FOREST MEADOWS SUBDIVISION

SUBDIVISION APPLICATION SB#03-21 CUP#03-21 STAFF REPORT

July 28, 2021

PLANS UNDER REVIEW: "Forest Meadows" Map 237 – Lot 032 Hudson, New Hampshire; prepared by Meisner Brem Corporation, 142 Littleton Road, Westford, MA 01886; prepared for KLN Construction Company, Inc., 70 Bridge Street, Unit 1, Pelham, NH 03076; consisting of 16 sheets, with General Notes 1-12 on Sheet 2; dated April 5, 2021, last revised June 7, 2021.

MSKT GUARDRAIL END SECTION BY ROAD SYSTEMS, INC

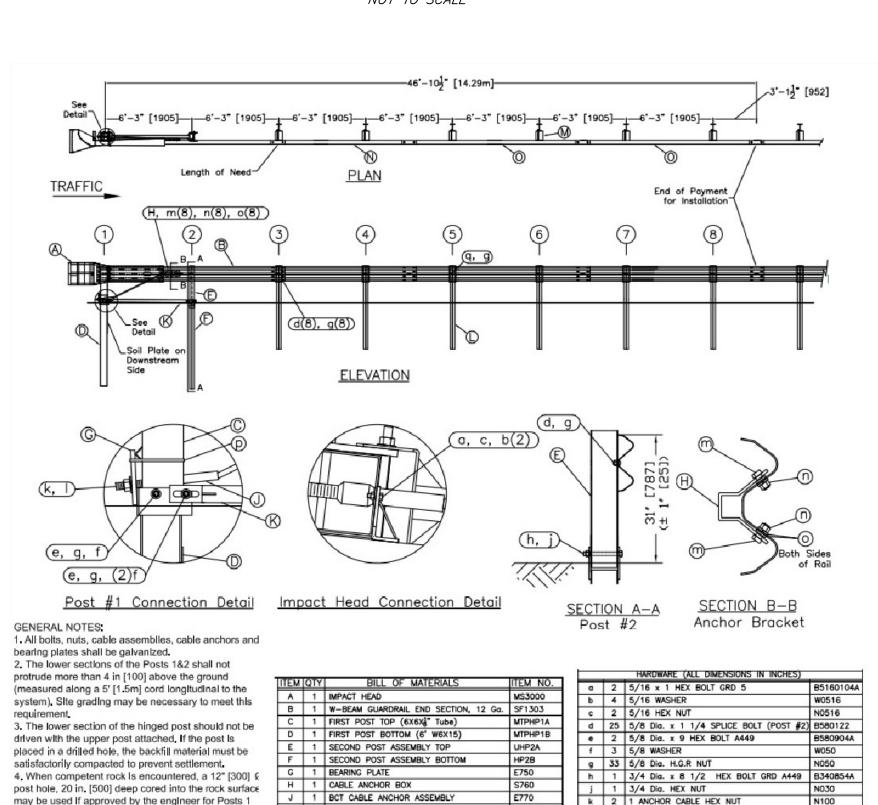
- Applicant has added a retaining wall to eliminate side slope and grading issues.
- A revised landscaping plan in accordance with the Applicant's discussion with the abutters.
- Applicant has addressed the guardrail and frozen ground conditions.
- A cobra head light has been added at the intersection, but staff recommends a note or condition be added stating "Street light shall conform to Town standard."

- 1d. A detail for the guard rail end section is added to sheet 3. End Section proposed is MSKT by Road Systems, Inc. NHDOT guidance documents available on-line indicate this product is approved by NHDOT for rail heights up to 31 inches.
- 4d. Stone wick label on sheet 13 is updated to specify the detail is located on sheet 14, rather than sheet 15.
- 4f. Alteration of Terrain application was recently submitted to NHDES with a copy provided to the Hudson Engineering Department. It should be noted that the stormwater model does use Site Specific soils and not the NRCS soil types. See Subcatchment Drainage Maps previously provided. The stormwater model submitted to NHDES is identical to the one reviewed by the Town & Peer Review.
- 7a. Construction fence detail is added to sheet 13. Fence locations along 50 ft wetland buffer are added to sheet 10.
